WATERLOO METRO QUARTER DEVELOPMENT

Site Plan

RTS Changes

Level 6-15 Plan

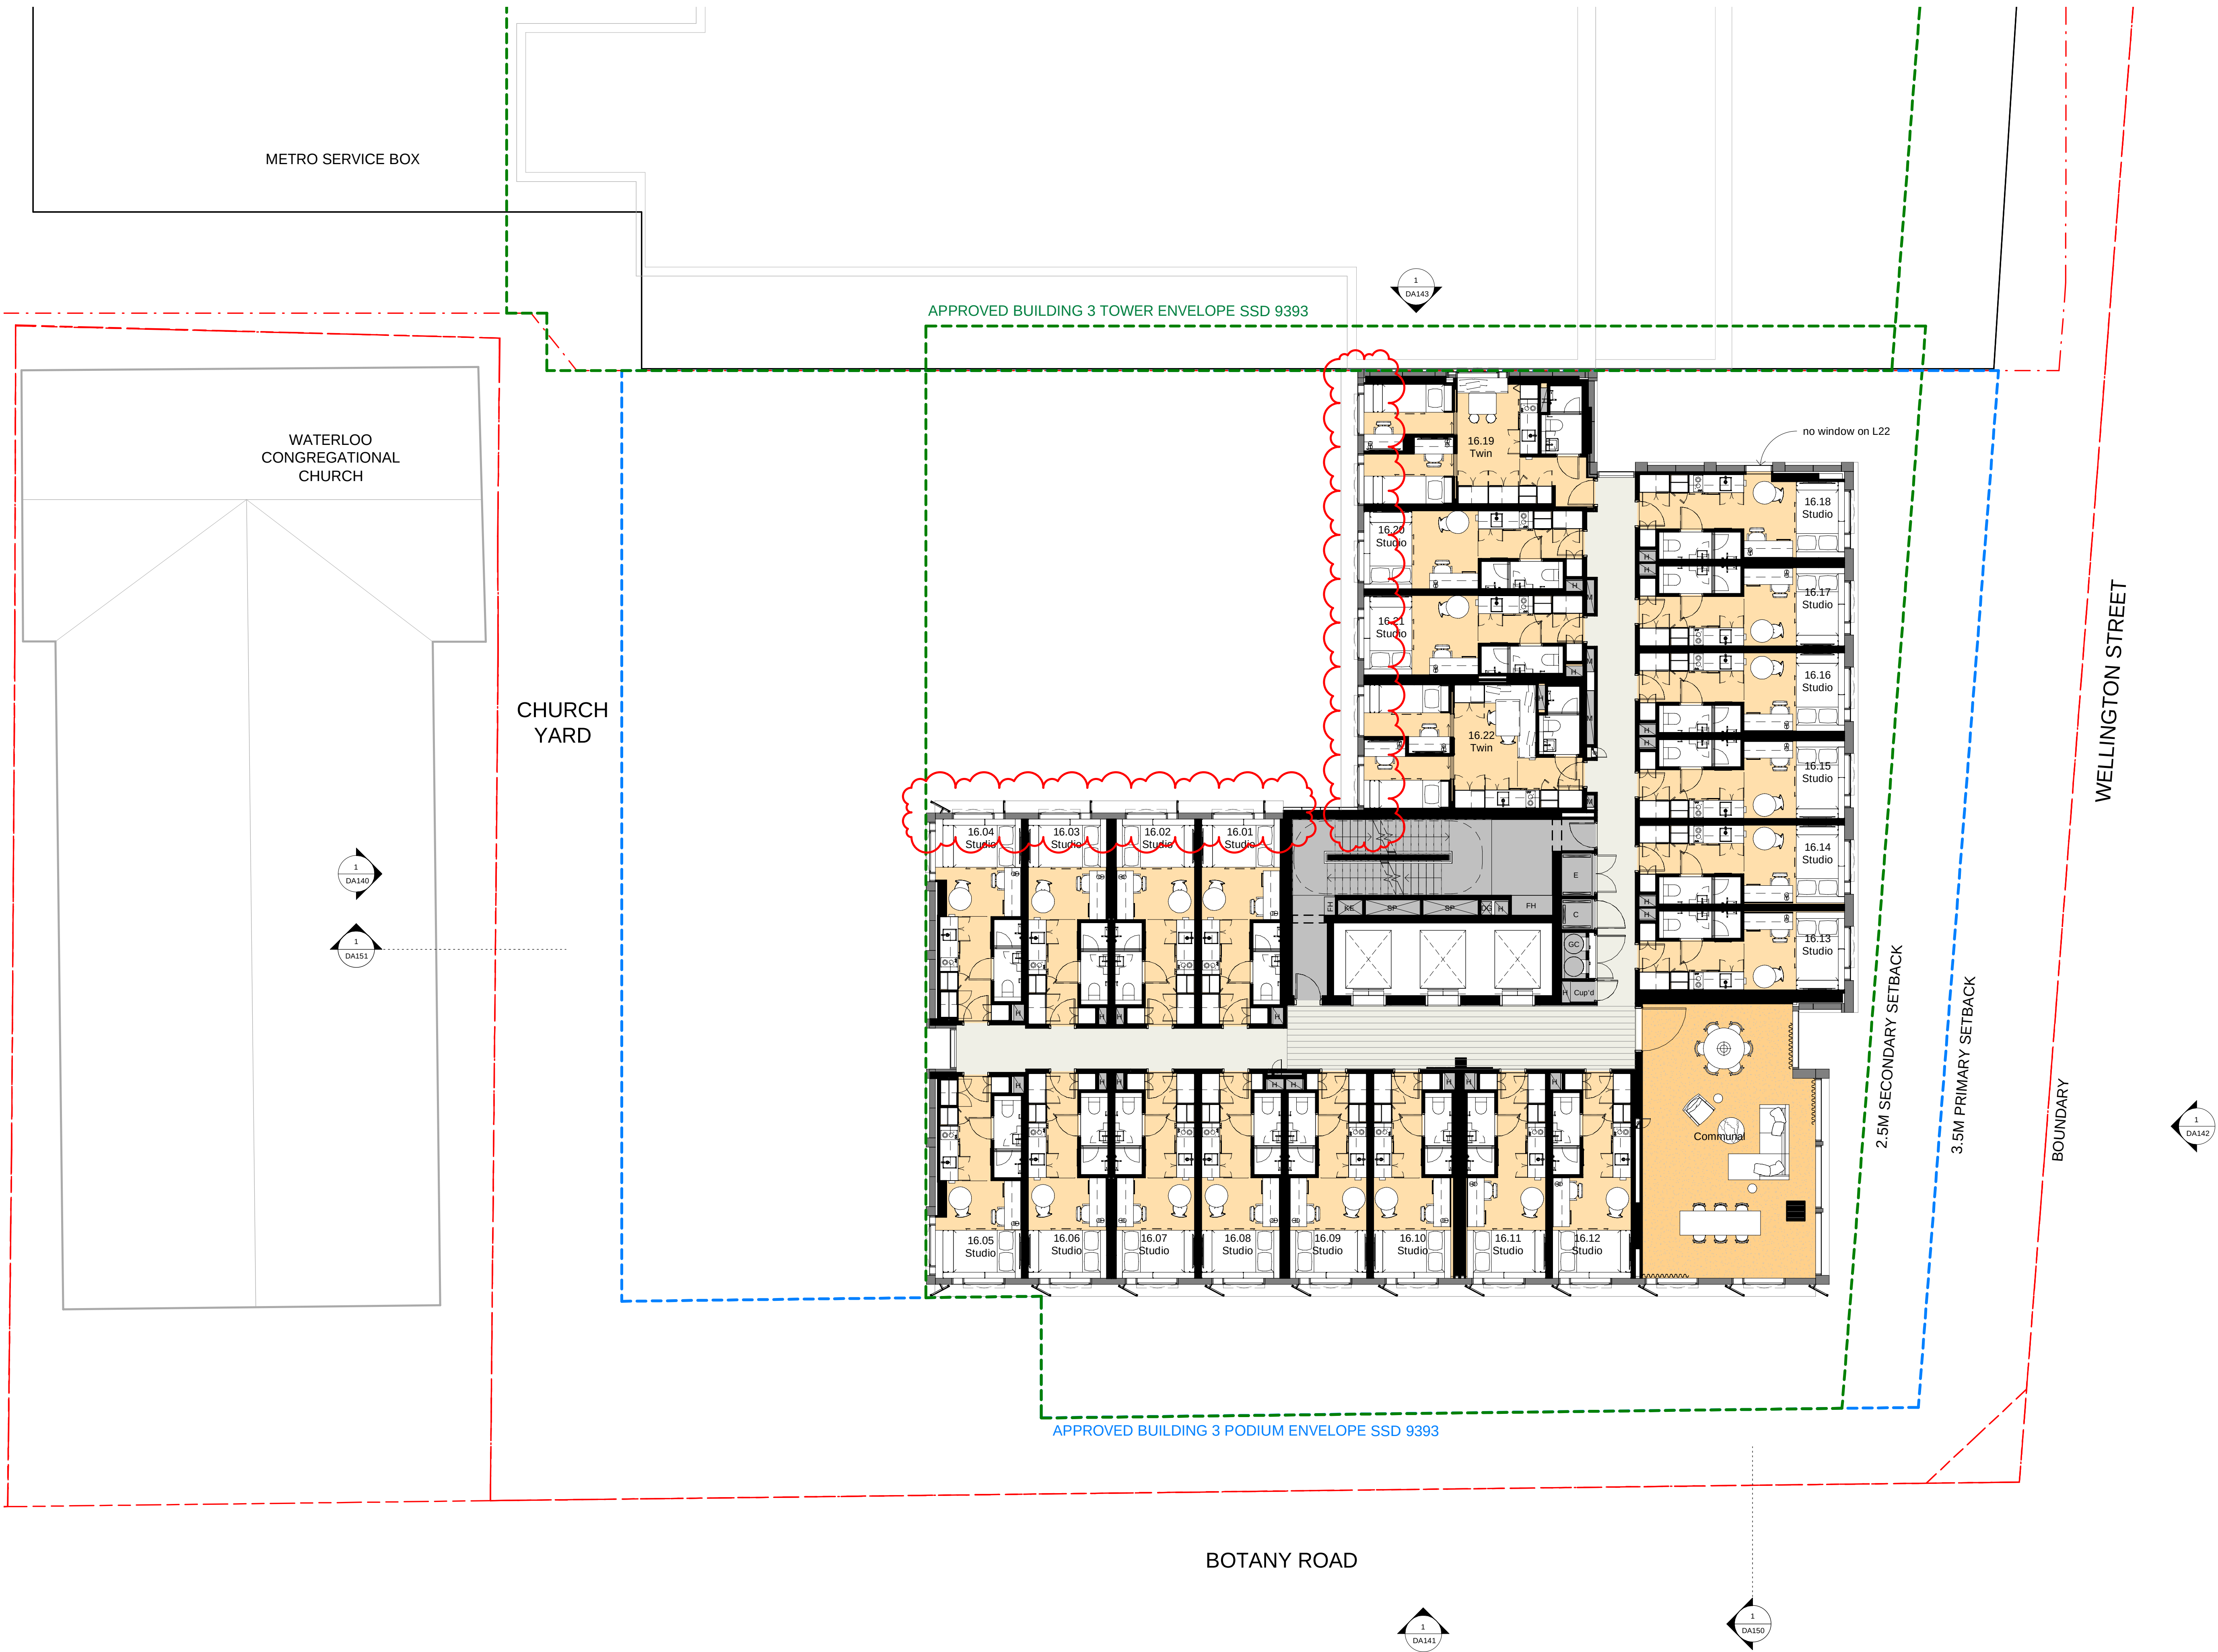
- RTS Changes
- Change to Vertical Privacy Screen on Eastern Facade
 - Change to Horizontal Sun Shades on Northern Facade

General Arrangement Plan
Level 16-22 Plan

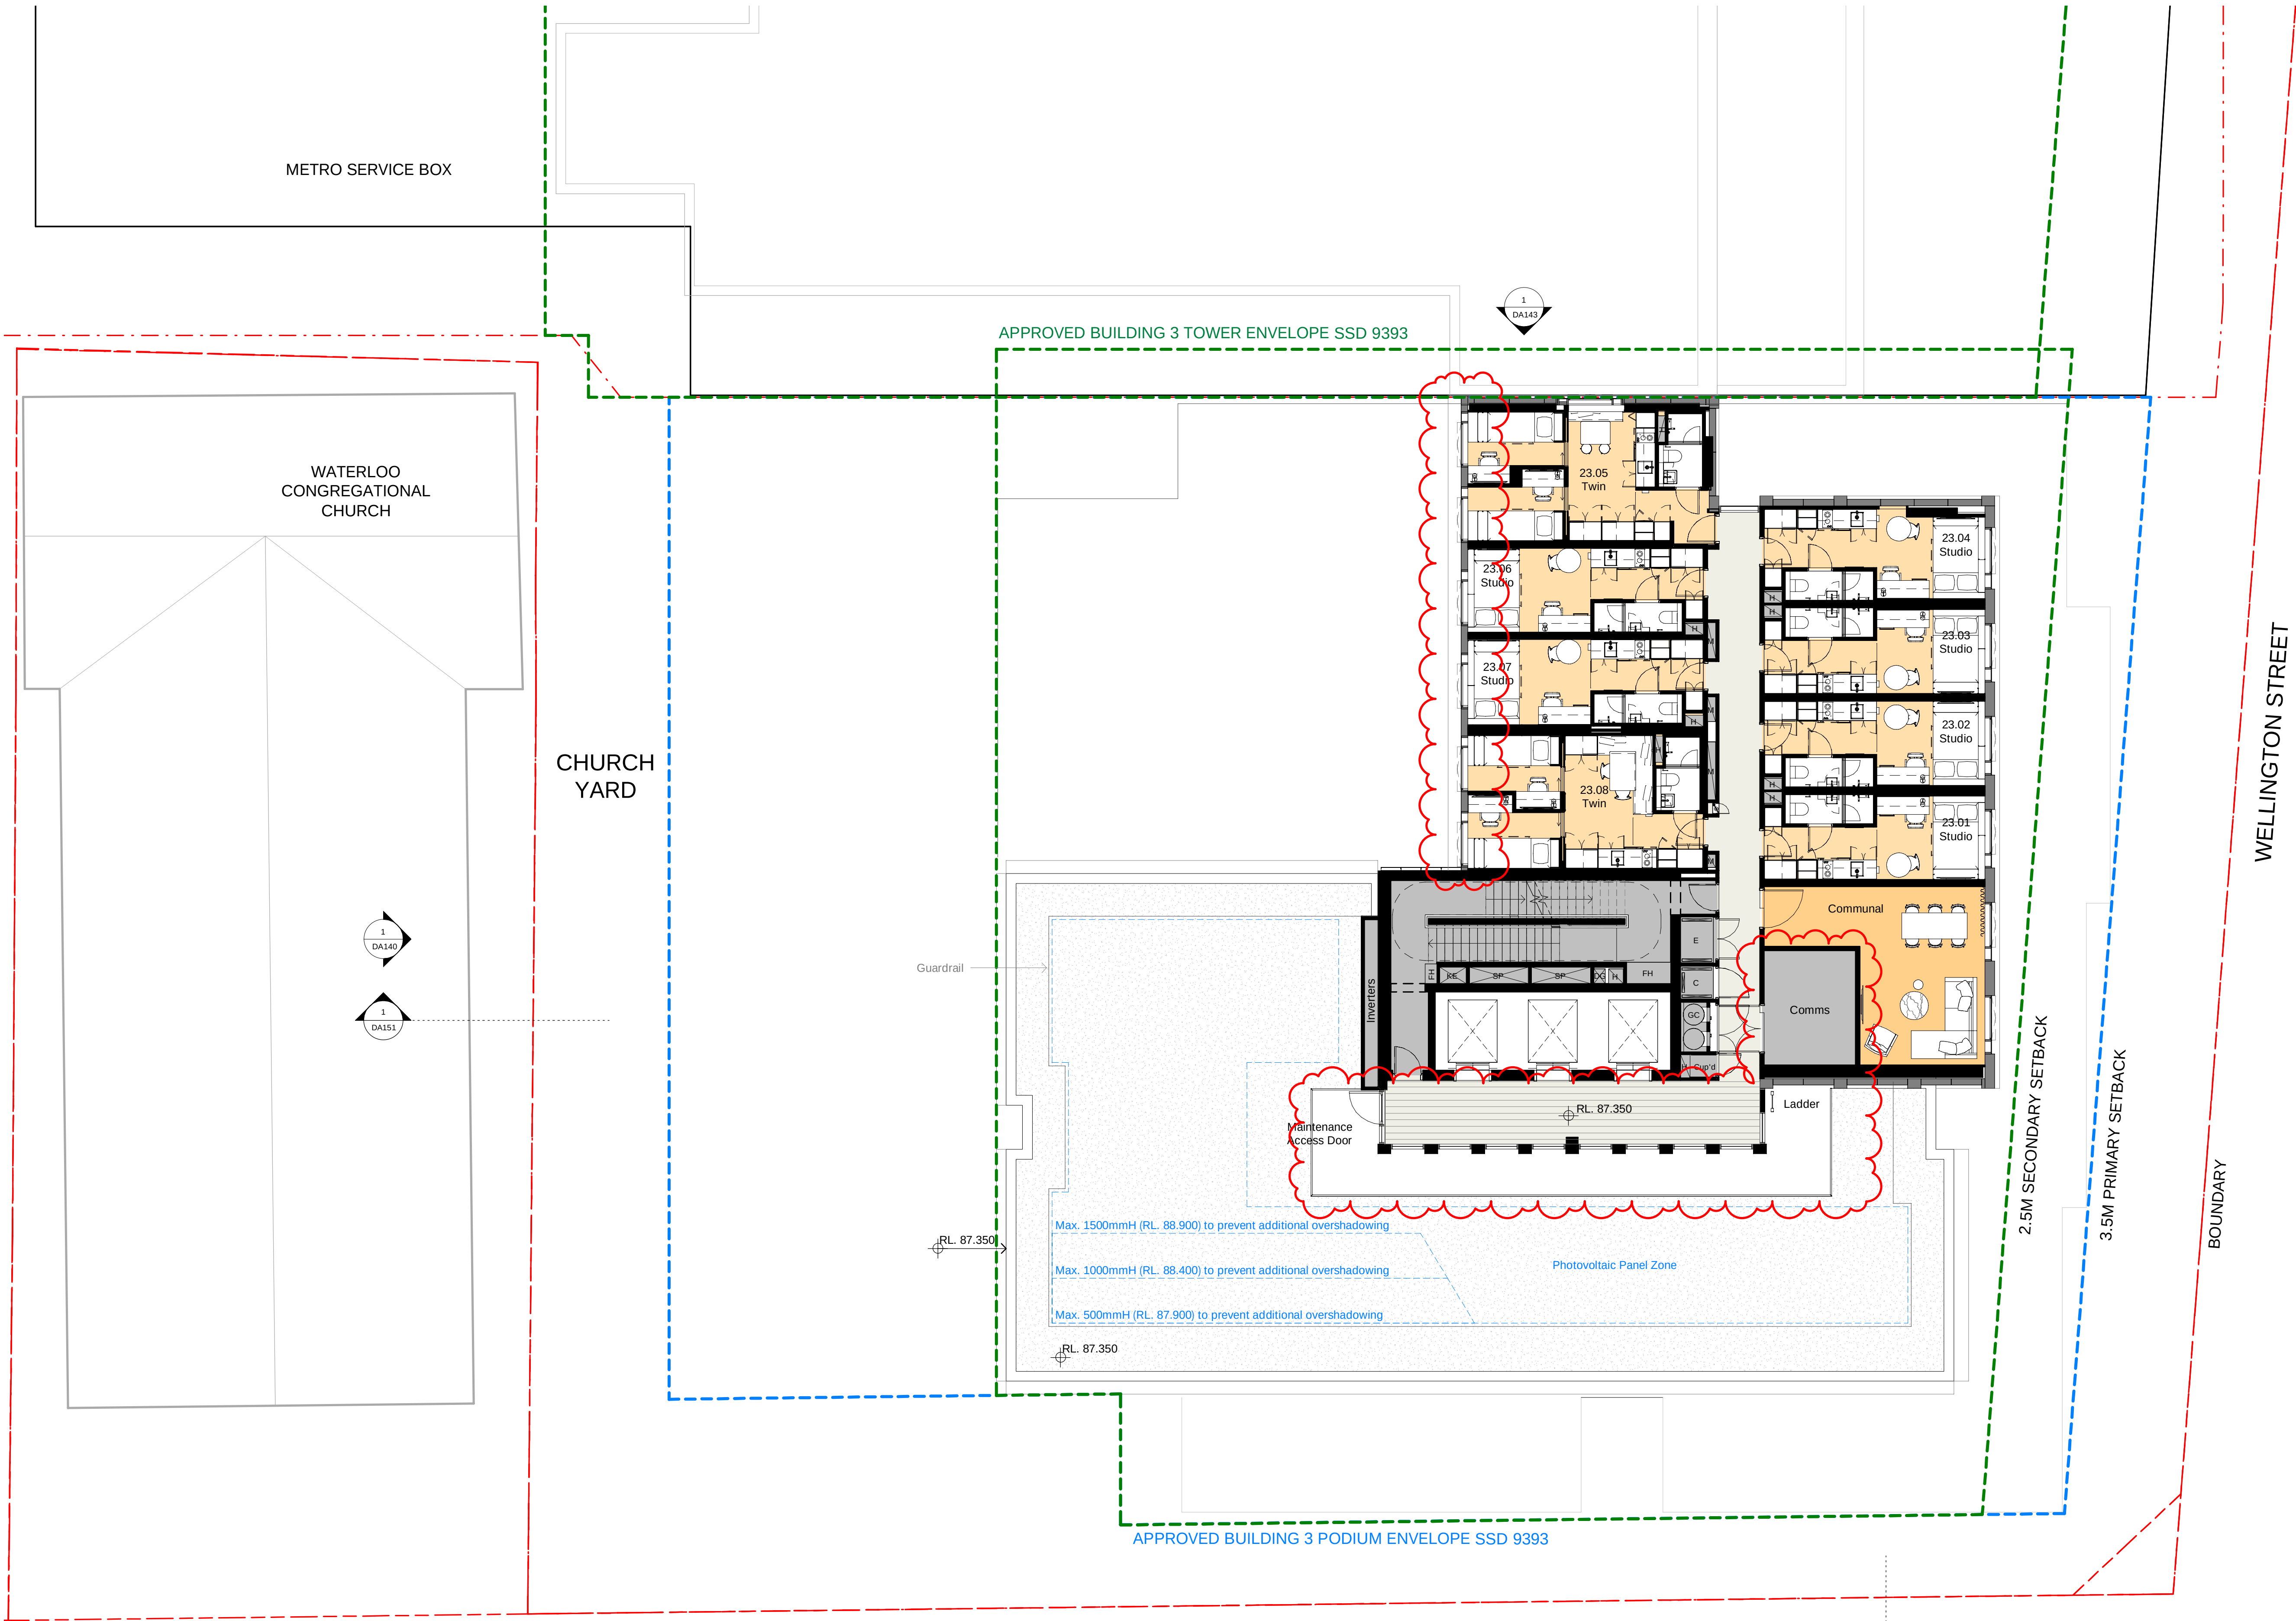
- RTS Changes
- Comms Room Relocation from Roof to Level 23
 - Change to Horizontal Sun Shades on Northern Facade
 - Addition of Guard Rail

Sheet title
General Arrangement Plan
Level 24 (Plant) Plan

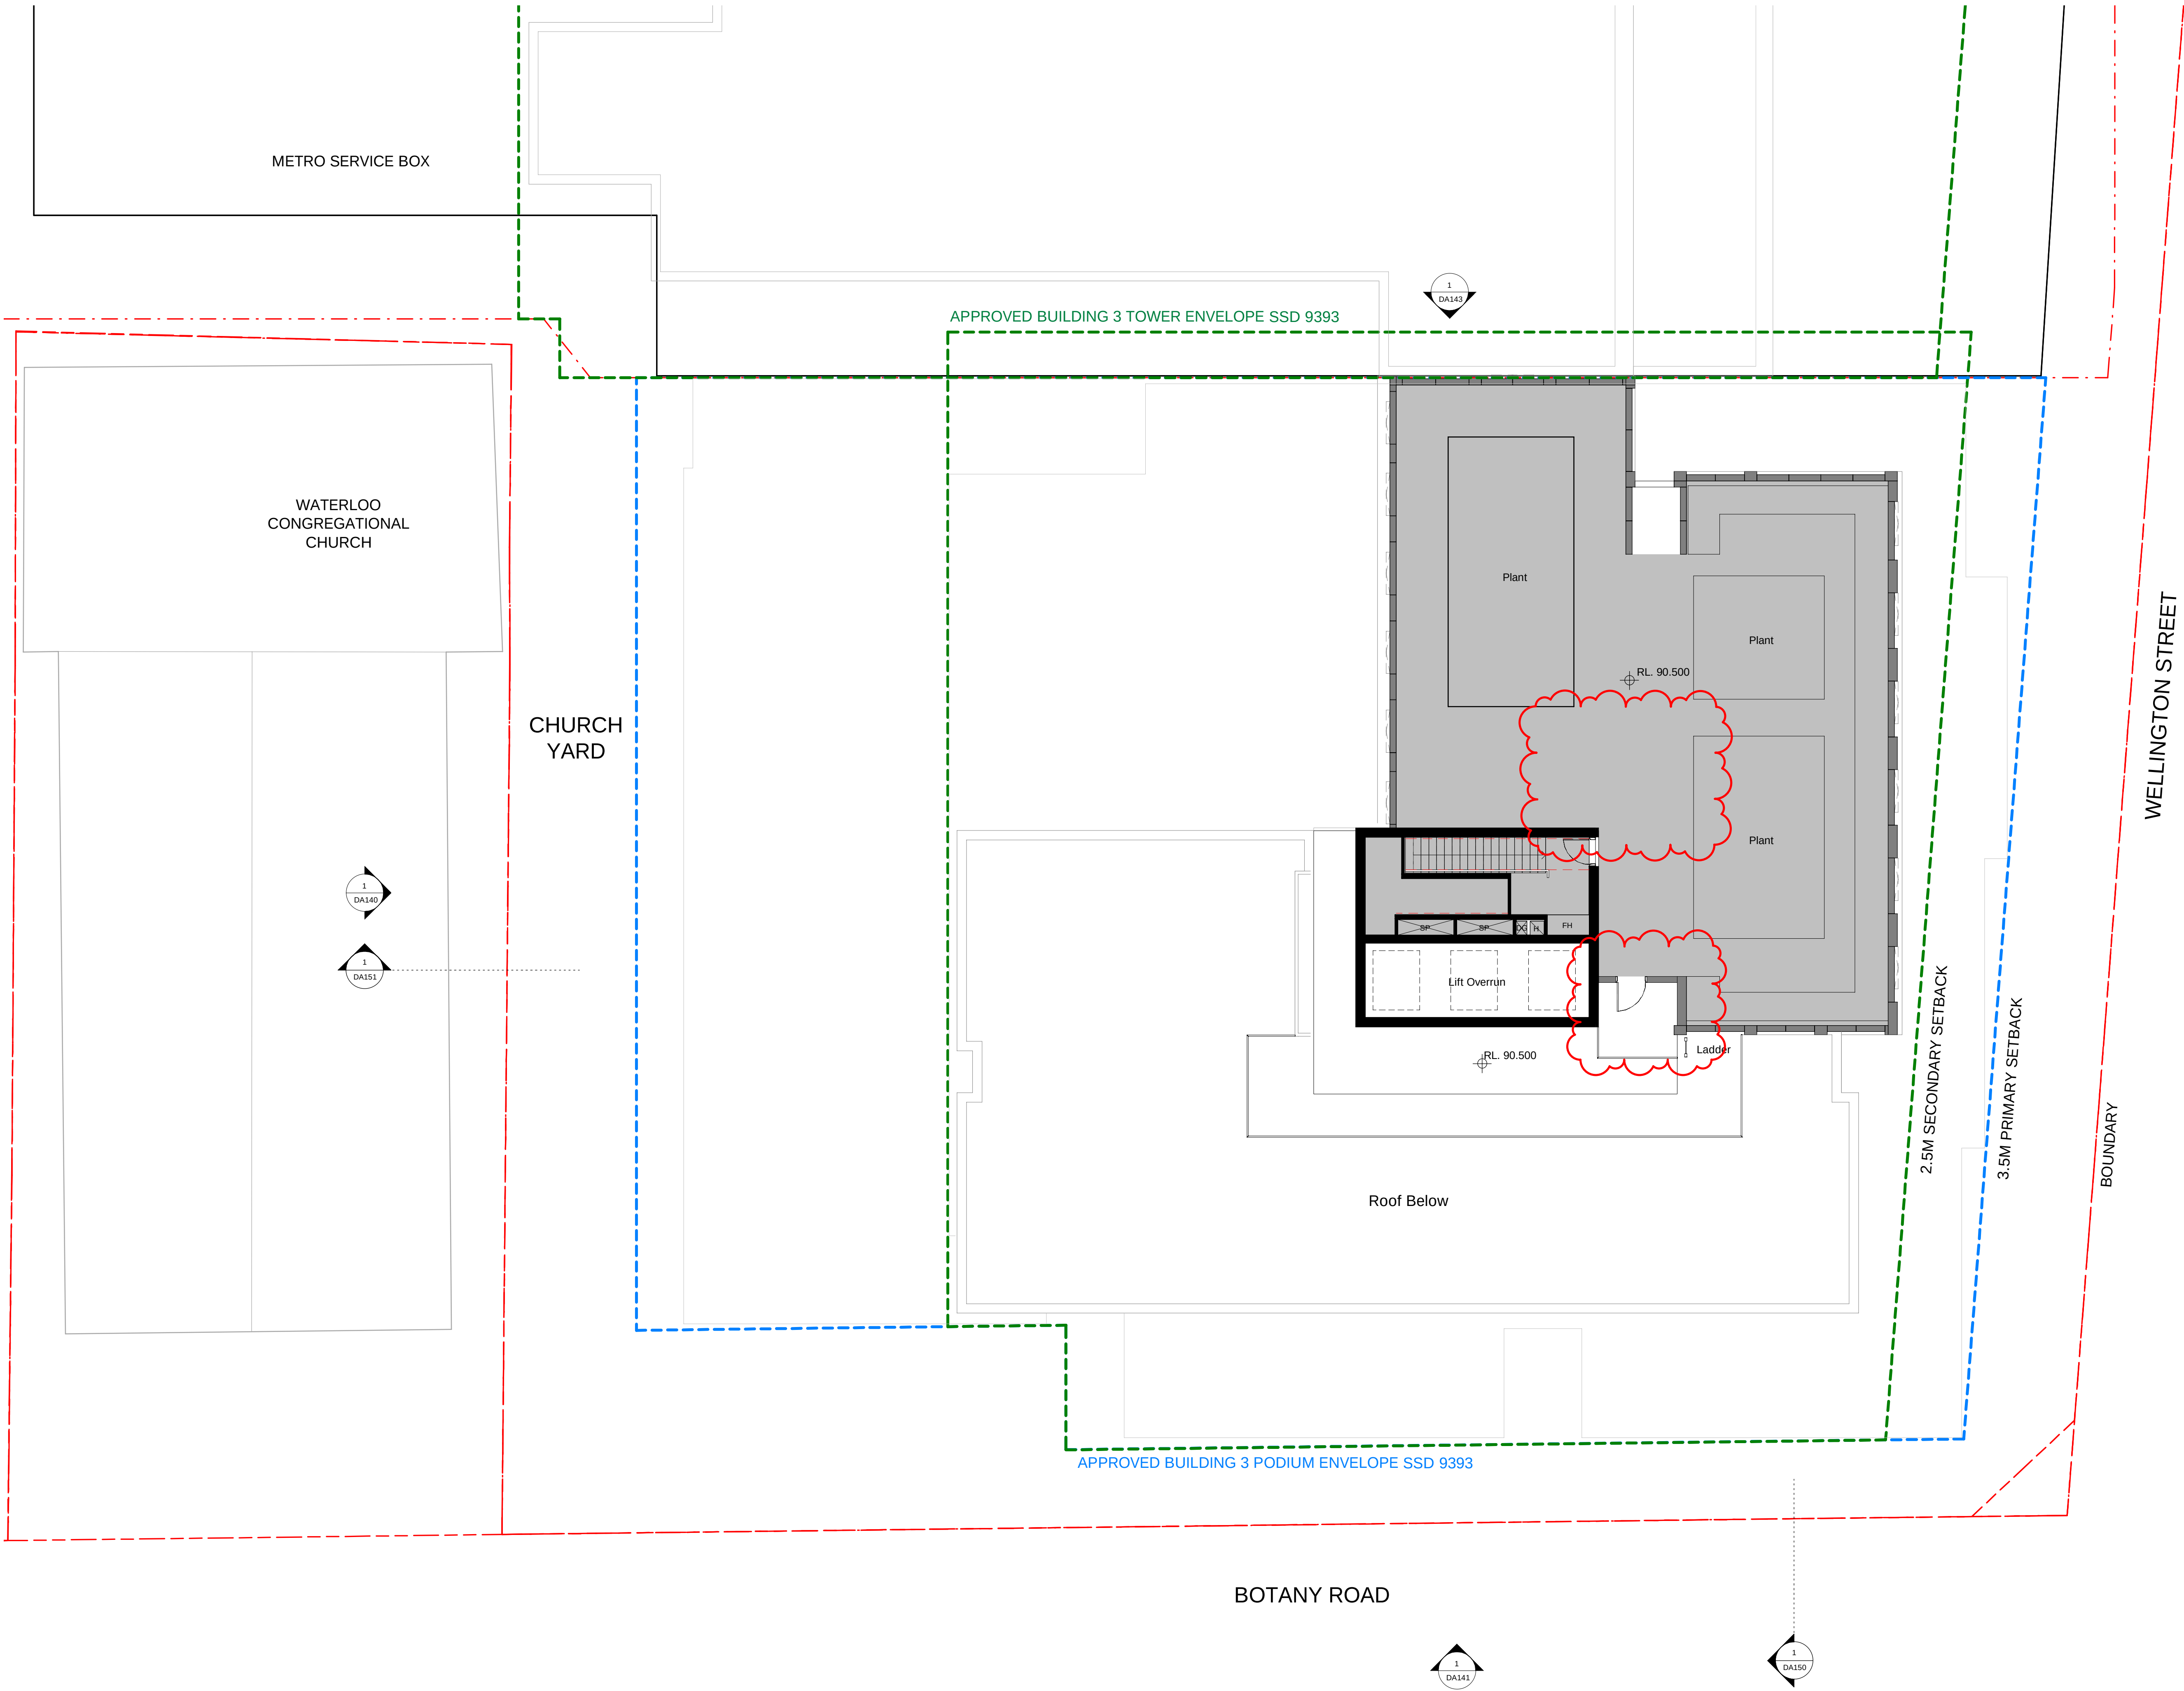
- Comms Room Relocation from Roof to Level 23
- Addition of Guard Rail
